WINCHESTER SOUTH PROJECT  
WATER AND FINAL LANDFORM ADDENDUM

JUNE 2023  
Project No. WHC-18-62  
Document No. 01185344-006.docx

WHC-18-62\_IR\_008B

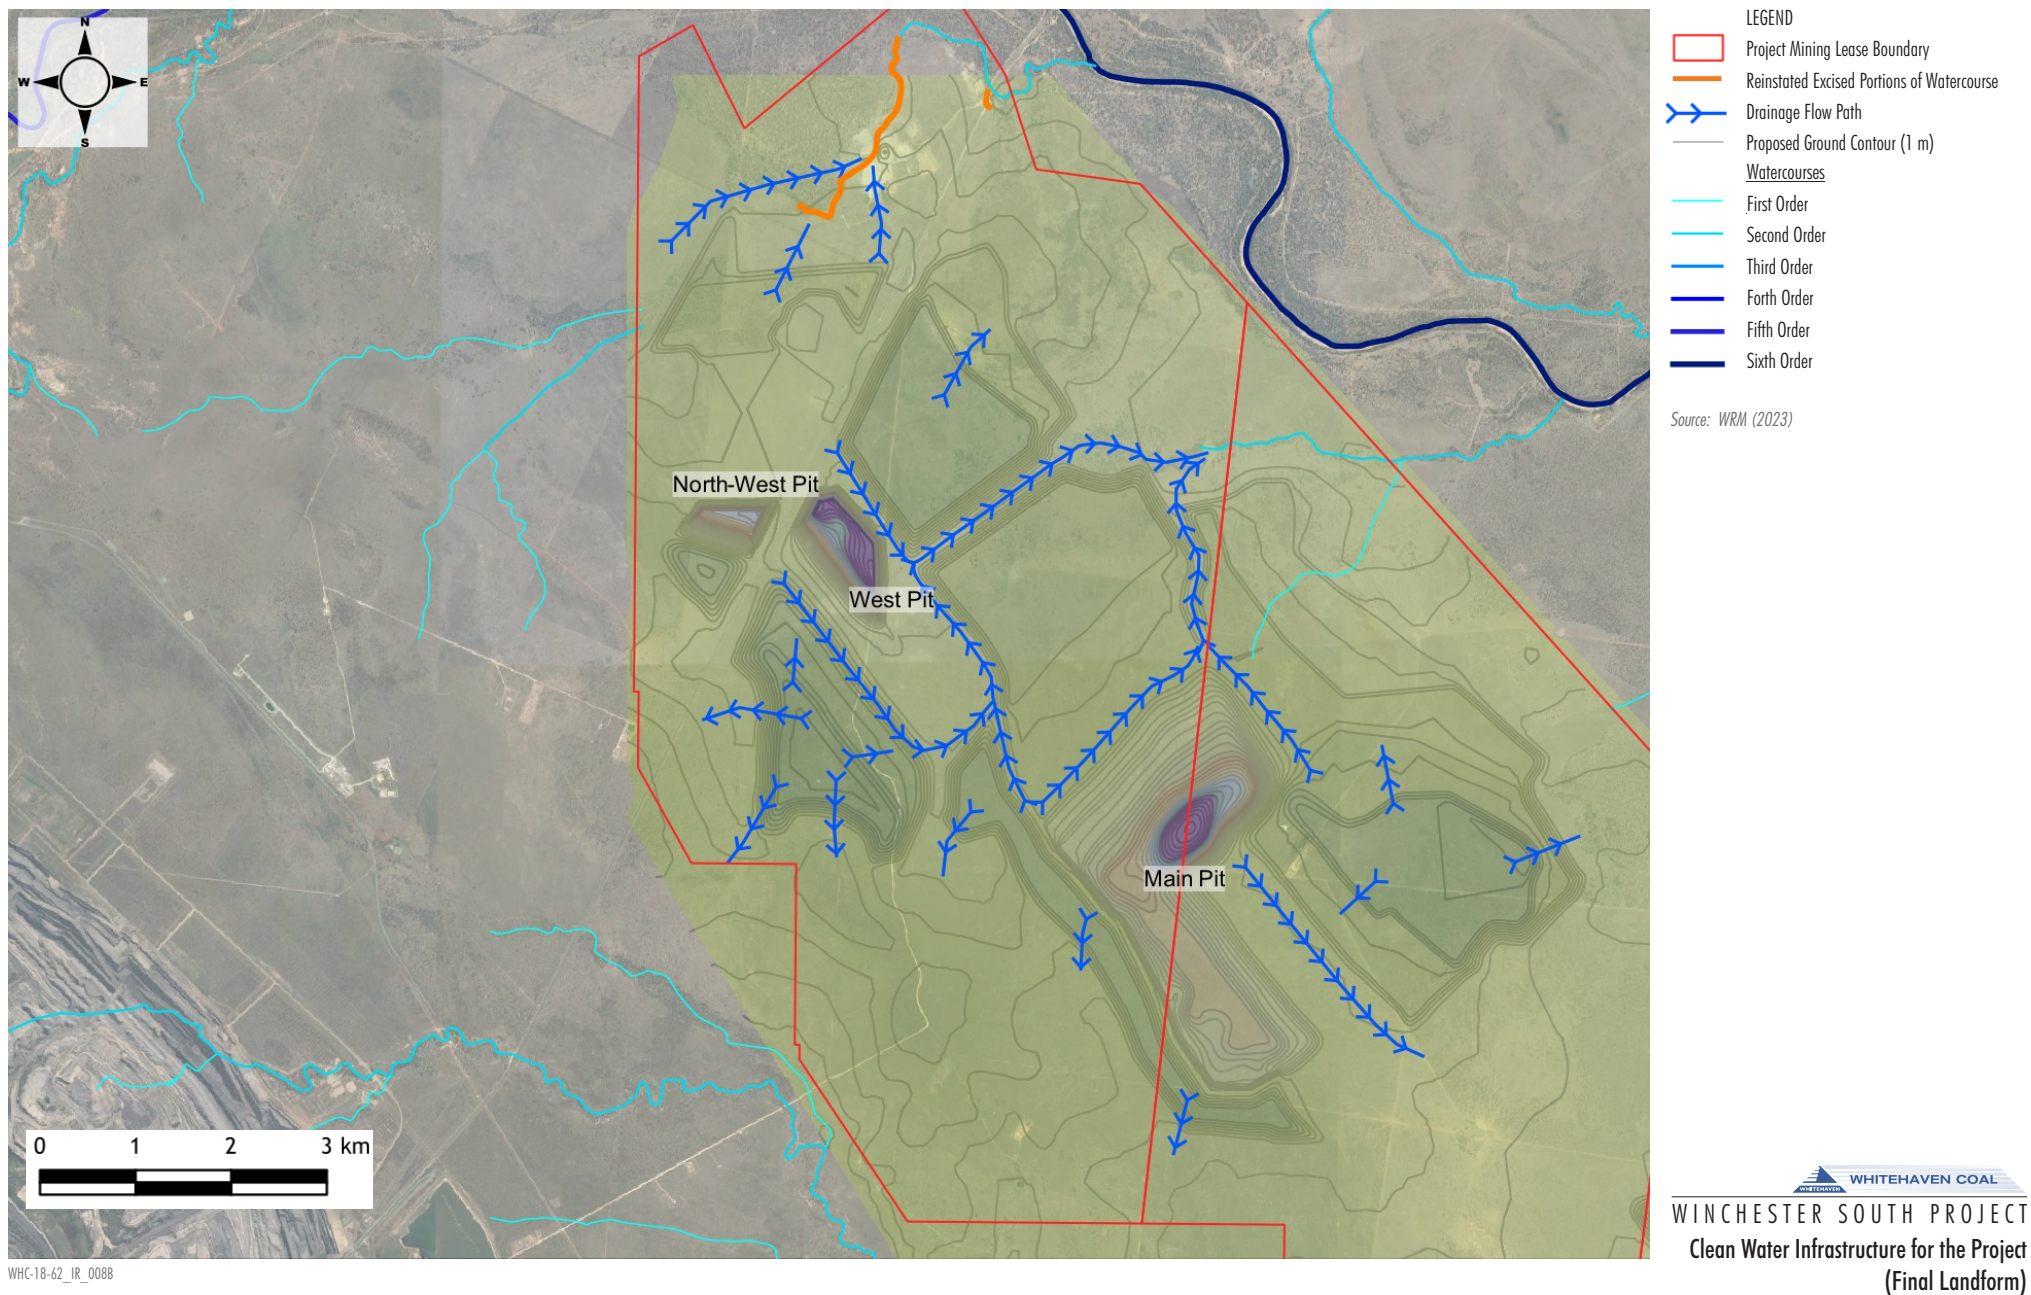
Section 2.7 (water management) of the project description lists CWD 1 and 2 as proposed water storages, and shows CWD 1 on Figure 2-5.

Clean Water Dams (CWD) 1 and 2 are shown in the DEIS SWFA on figures 5.3, 5.4 (proposed water management system) and Figure 6.2 (water management system schematic), and Table 6.5 where CWD 1 has a design storage volume (DSV) of 26ML and a total storage volume (TSV) of 523ML, and CWD 2 has a DSV of 56ML and TSV of 1,121ML. CWD 1 and 2 will impound flows related to the unnamed central waterway.

The size and operation of the clean water dams was raised in a submission on the DEIS from DRDMW (DEIS issue 452.03). The submission noted that the dams proposed to capture overland flow had a maximum capacity greater than 50ML, and under section 110, 2(b) of the Water Plan (Fitzroy Basin) 2011 would require a water licence under the Water Act 2000.

Section 5.6.1 of RDEIS Attachment 6 (SWFA) has removed reference to CWD 1 and 2 in text and figures and now states: Whitehaven WS may implement alternative clean water diversions over the life of the Project to divert water around active operations. This could potentially include diversions/embankments that are located further upslope than the indicative locations shown on Figure 5.1 to Figure 5.6 (within the proposed Project footprint) and/or clean water dams and associated pumping infrastructure.

In response to DES issue 584.32 on the RDEIS, the following direction to the proponent was given: Provide a detailed description of the design and location of clean water management system (including waterway diversions) to ensure all relevant potential impacts are identified and adequately assessed.

Whitehaven's response to this issue referred to four dams in the MIA (in the context of another section of the direction to proponent around MAW storage capacities) and conditions F29 and F30 which relate to the water management plan. No further details of the clean water management systems are provided.

In response to DES issue 584.83 the following direction to the proponent was given: Provide a revised list of draft EA conditions and the required management approach that includes details of temporary and permanent disturbance of water flow paths/patterns, including levees, regulated structures and other water management infrastructures such as diversions. Provide maps at suitable scale for all locations.

A series of up-catchment clean water drains are proposed to temporarily divert clean runoff water around the active mining areas. The indicative locations of the clean water drains for the various phases of the Project are shown on Figure 3-1A to Figure 3-1F. Diverting clean water around the mining areas has multiple benefits to operations and the receiving environment (compared with capturing all up-catchment runoff), namely:

Alternative clean water management strategies and infrastructure may be implemented over the life of the Project to divert water around active operations. This could potentially include development of additional drains/embankments as required. Detailed design of water management infrastructure would be outlined in the Water Management Plan for the Project and updated over the life of the Project. As described above, the indicative locations of clean water drains are shown in Figure 3-1A to Figure 3-1F. The drainage pathways for the rehabilitated final landform are shown on Figure 3-1G.

- Project Year 1 to Project Year 6 (Phase 1) operations shown in Figure 3-1A:
  - A clean water drain (DRAIN-1) diverts clean runoff around the south and west of the Railway Pit.
  - A clean water drain (DRAIN-2) diverts clean runoff around the east of the Railway Pit mining area.
  - A clean water drain (DRAIN-3) diverts clean runoff around the south of the Mine Infrastructure Area.
- Project Year 7 to Project Year 11 (Phase 2) operations shown in Figure 3-1B:
  - DRAIN-1 remains, diverting clean runoff around the south and west of the Railway Pit.
  - DRAIN-2 is removed as part of mining activities.
  - A clean water drain (DRAIN-4) diverts clean runoff around the south and east of the Main Pit North.
  - DRAIN-3 is removed as part of mining activities.
  - A clean water dam (CWD1/CWD2) (if required) temporarily holds clean runoff diverted via DRAIN-4.

- Project Year 12 to Project Year 16 (Phase 3) operations shown in Figure 3-1C:
  - DRAIN-1 remains, diverting clean runoff around the south and west of the Railway Pit.

- CWD1/CWD2 (if required) is removed as part of mining activities.
- Project Year 17 to Project Year 21 (Phase 4) operations shown in Figure 3-1D:
  - DRAIN-1 remains, diverting clean runoff around the south and west of the Railway Pit.

- A clean water (DRAIN-7) diverts clean runoff around the south of the out-of-pit emplacement, draining south towards a tributary of Ripstone Creek.
- Project Year 22 Project Year 26 (Phase 5) operations shown in Figure 3-1E:

- DRAIN-7 remains, draining south towards a tributary of Ripstone Creek.
- Project Year 27 to Project Year 29 (Phase 6) operations shown in Figure 3-1F:

**Figure 4-1A**

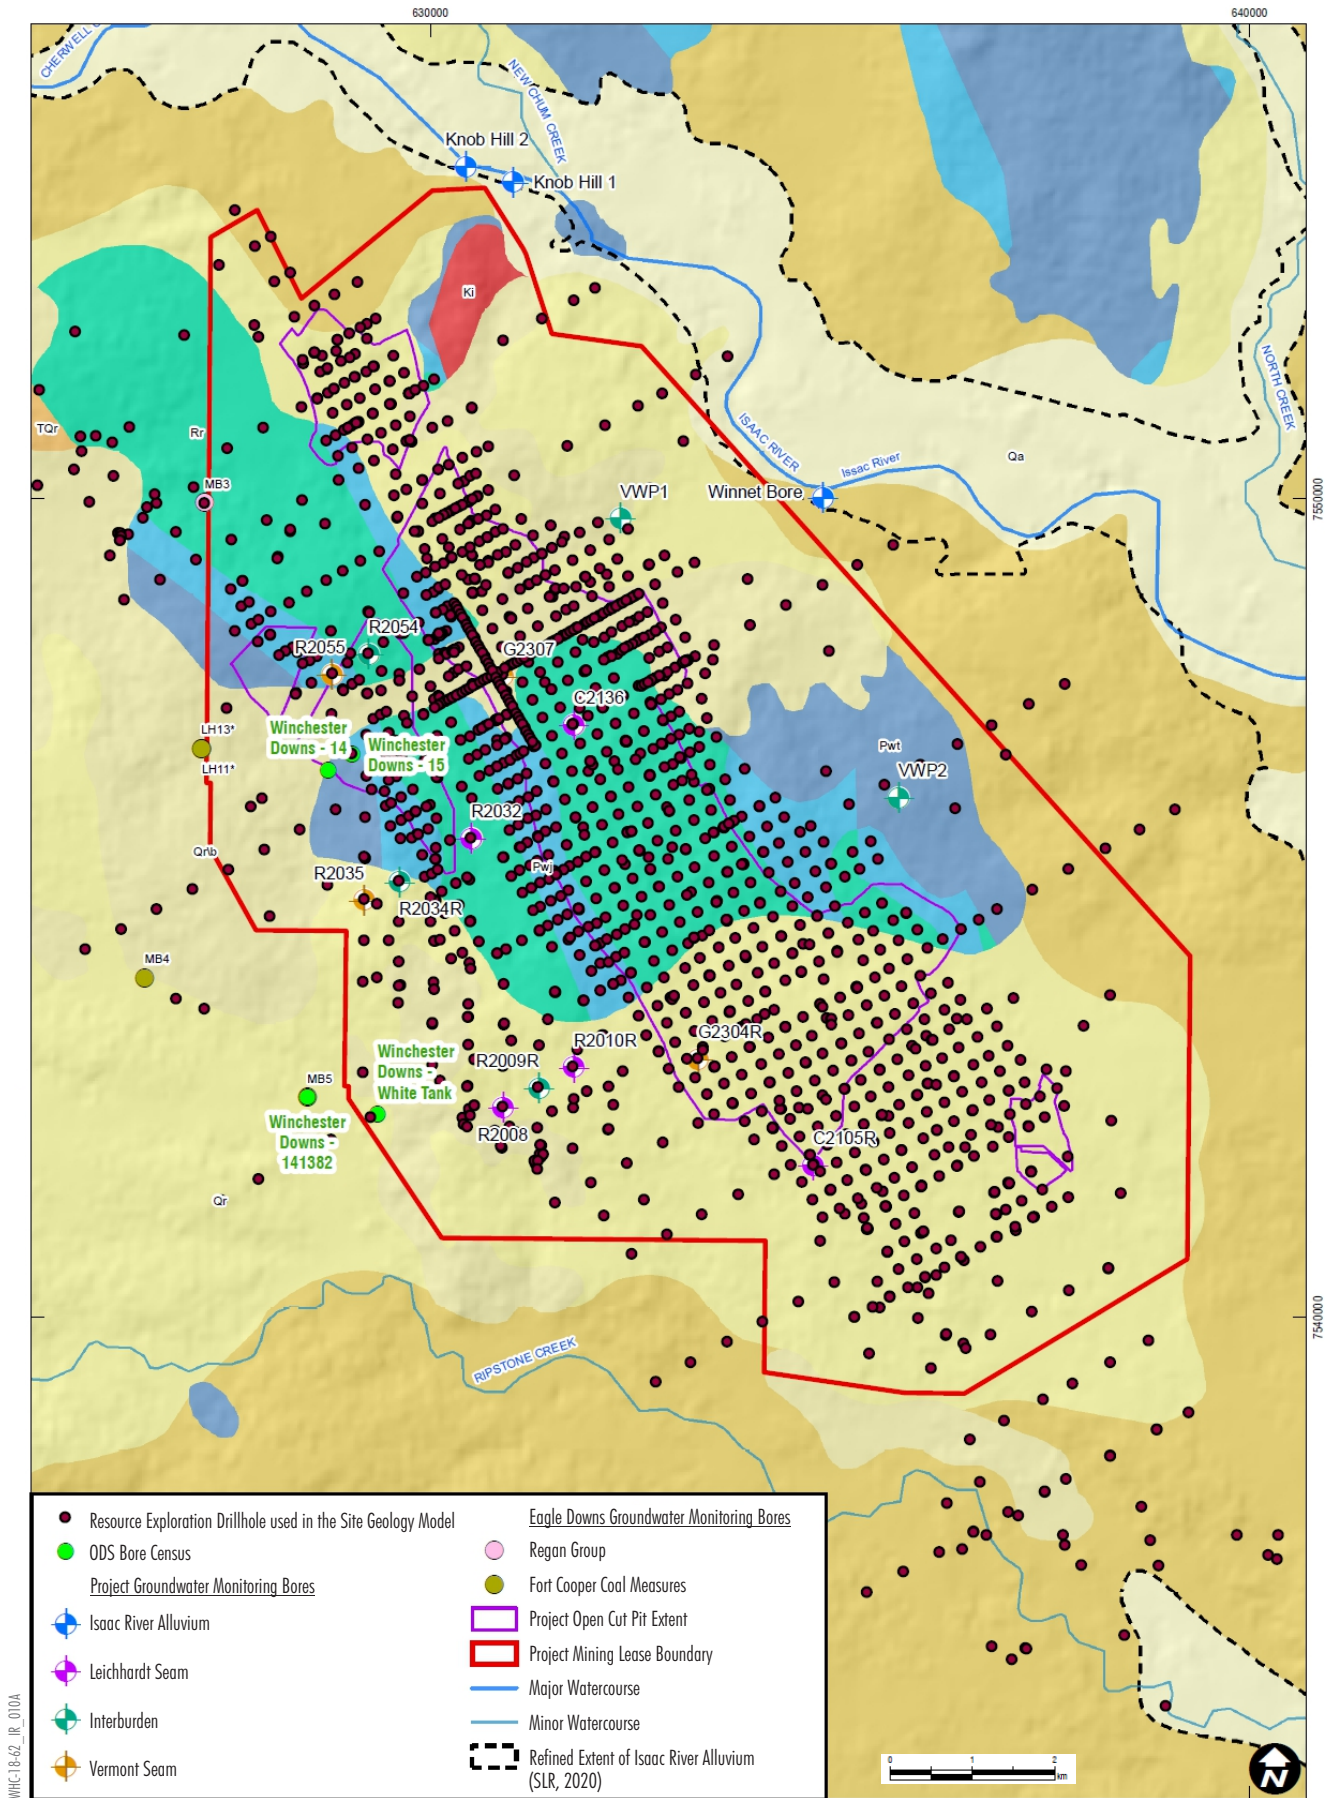
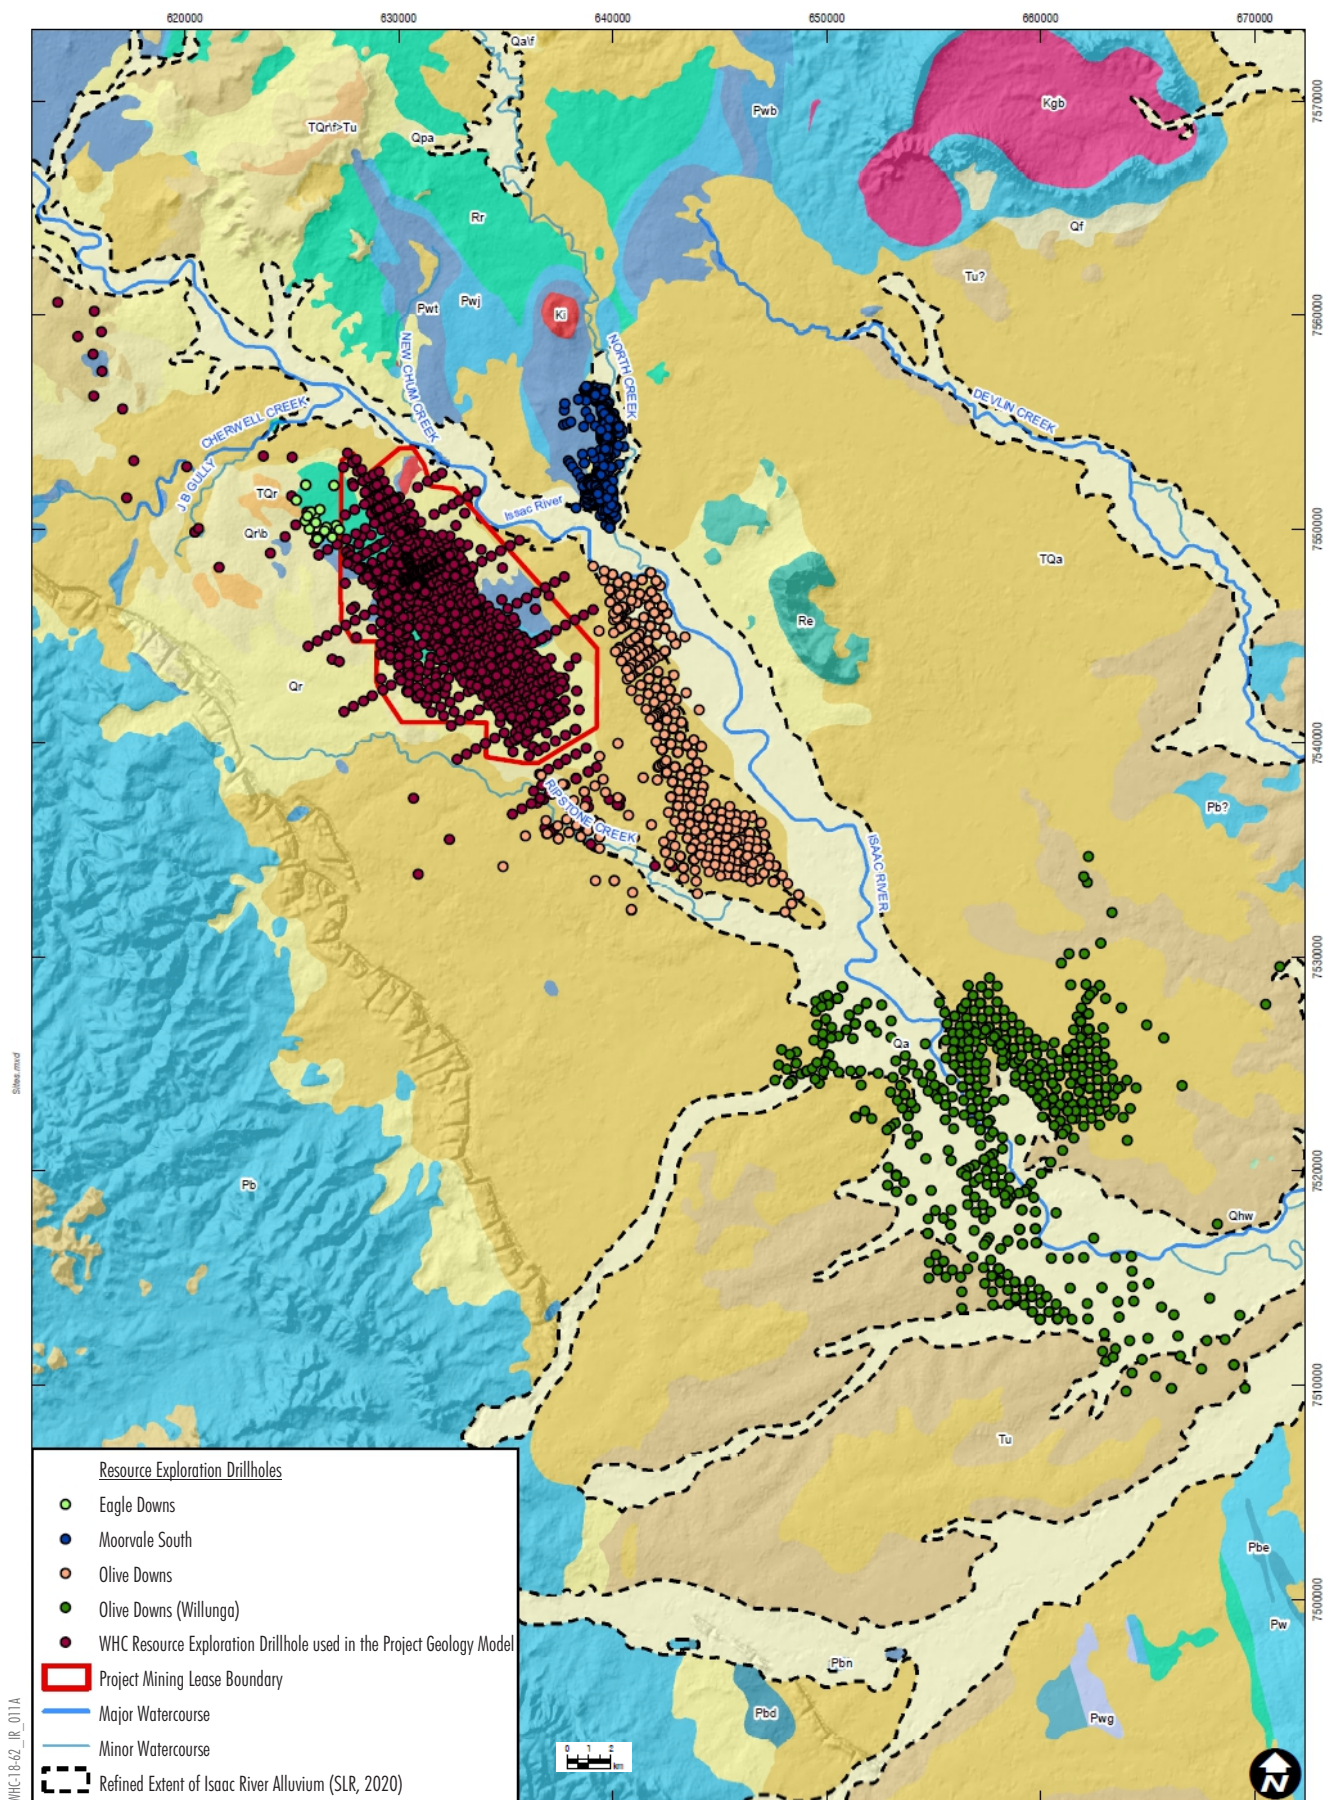
- DEIS Appendix F – Integrated assessment of Impacts on Groundwater Dependent Ecosystems
  - No alluvial drillhole/log data or TEM analysis is included. A figure of the drillhole locations (WSN204-7) and TEM surveys for palustrine wetland 2 (close to the rail loop and MIA) is included (Fig 12) but there is no discussion of results, only a statement that the conclusion that the aquatic ecosystems associated with the wetlands don't receive groundwater recharge is supported by drillhole logs and TEM surveys which confirm the presence of clay-rich sediments near the surface. It is not clear the extent of drillholes in the area, and it is not clear if clay-rich sediments were found in all drillholes.

- Depth to groundwater is stated to be 10-20 mBGL (SLR 2021 is referenced) under the GDEs, and depth to groundwater contours are shown on Figure 5 and Figure 10, however it is not clear where this information comes from. Figure 5 references Whitehaven 2017 and 2020, and Figure 10 also references SLR 2021. Section 4.4.1 refers to bore records provided by Oasis Hydrology (pers. comm. 2019) but the logs are not provided and there is no discussion of the logs within the text.

Item 3 of the Groundwater RFI suggests there are four groundwater bores with evidence of some saturation of the regolith unit in the south-west of the Project area, which is predicted to be unsaturated in this area by the numerical groundwater model. The four groundwater bores listed below were identified in the Groundwater Assessment for the Olive Downs Project and are shown in Figure 4-1A:

The Project Site Geology Model included data from over 1,500 exploration drillholes and geophysical investigations, locations shown in Figure 4-1A. The numerical groundwater model for the Project also used site geology models from the Moorvale South Project and Olive Downs Project that were also developed using the exploration drillholes shown in Figure 4-1B. The exploration drillholes and site geology models were incorporated into the model layers for the numerical groundwater model. This included extensive exploration drillhole data from the regolith (Figures 4-1A and 4-1B).

A review of the groundwater bores listed is provided below, however, it should be noted that Figure 3-3 and 3-6 in Appendix B of the Groundwater Assessment show the predicted water level within the regolith (Model Layer 2) at the end of mining for Project-only and cumulative scenario, that is the predicted water level after the drawdown from the Project-only and cumulative mining activities, and therefore should not be compared to the pre-mining groundwater levels observed at Winchester Downs 14 Bore, Winchester Downs 15 Bore, White Tank 14 Bore and Bore 141382 as has occurred in Item 3 of the Groundwater RFI.

The measured depth of Winchester Downs 14 bore was 14.4 m which was identified in the bore census for the Olive Downs Project Groundwater Assessment. The Winchester Downs 14 bore was recorded as being in 'poor' condition and abandoned. The poor condition, disused status, and lack of bore logs reduce the reliability of measurements made from the Winchester Downs 14 bore. At this location, the base of the regolith is at a depth of 14.5 m based on the Project Site Geological Model, informed by the exploration holes shown on Figure 4-1A. The closest exploration hole (WSC1123) with detailed lithology information is approximately 480 m east of Winchester Downs 14 and reports a base of regolith depth of 17 m. As such, it is expected the Winchester Downs 14 bore may access the regolith as suggested in Item 3 of the Groundwater RFI.

The measured depth of Winchester Downs 15 bore was 23.4 m which was identified in the bore census for the Olive Downs Project Groundwater Assessment. At this location, the base of the regolith is at a depth of 17.6 m based on the Project Site Geological Model, informed by the exploration holes shown on Figure 4-1A. The closest exploration hole (WSN1010) with detailed lithology information is approximately 250 m east of Winchester Downs 15 and reports a base of regolith depth of 16 m. As such, it is expected the Winchester Downs 15 bore does not access the regolith, but the top of the underlying fresh Permian strata.

The measured depth of White Tank bore was 53 m (rather than 14 m outlined in Item 3 of the Groundwater RFI) which was identified in the bore census for the Olive Downs Project Groundwater Assessment. At this location, the base of the regolith is at a depth of 21 m based on the Project Site Geological Model, informed by the exploration holes shown on Figure 4-1A. White Tank bore aligns closely with an exploration hole (WSN41) (i.e. indicating White Tank bore may in fact be WSN41), which has detailed lithology information that reports a base of regolith depth of 21.6 m. As such, it is expected the White Tank bore does not access the regolith, but the top of the underlying fresh Permian strata.

The measured depth of Bore 141382 was 51.3 m which was identified in the bore census for the Olive Downs Project Groundwater Assessment and is a monitoring bore from the Eagle Downs Mine monitoring network named MB5. At this location, the base of the regolith is at a depth of 25.7 m based on the Project Site Geological Model, informed by the exploration holes shown on Figure 4-1A. Review of the available bore log for Bore 141382 (MB5) reports a base of regolith depth of 16 m. As such, it is expected the Bore 141382 (MB5) does not access the regolith, but the top of the underlying fresh Permian strata.

As outlined in response to Items 1 and 2 of the Groundwater RFI, the Project Site Geology Model included over 1,500 exploration drillholes and geophysical investigations shown in Figure 4-1A. The numerical groundwater model for the Project also used site geology models from the Moorvale South Project and Olive Downs Project that were also developed using exploration drillholes shown in Figure 4-1B. The exploration drillholes and site geology models were incorporated into the model layers for the numerical groundwater model and included extensive exploration drillhole data in the regolith (Figures 4-1A and 4-1B). Explicitly, site-specific data (e.g. the Project Site Geology Model) was used to inform the depth and thickness of the regolith (as well as the other model layers) across the Project area as adopted in both the conceptualisation and numerical groundwater modelling.
